# POWERGLIDE ALUMINUM CLUTCH DRUM

Part #207020 - #205650 - #205651 - #205660

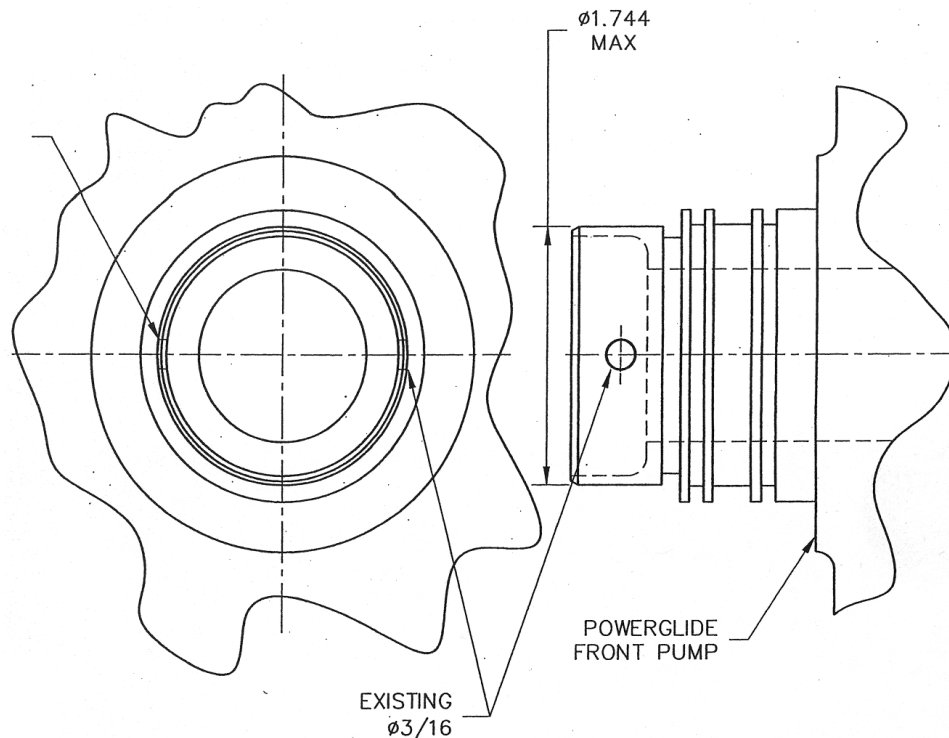
Engine RPM in excess of 8,000 RPM will require an additional 3/16 hole drilled directly opposite the existing hole in the front pump. Drill hole, break sharp edges and remove burrs.

- As of January 2015, all ATI pumps have extra lube holes added.
- All aluminum drums now have a steel sleeve installed for Teflon ring use and a Teflon coated bushing is installed.
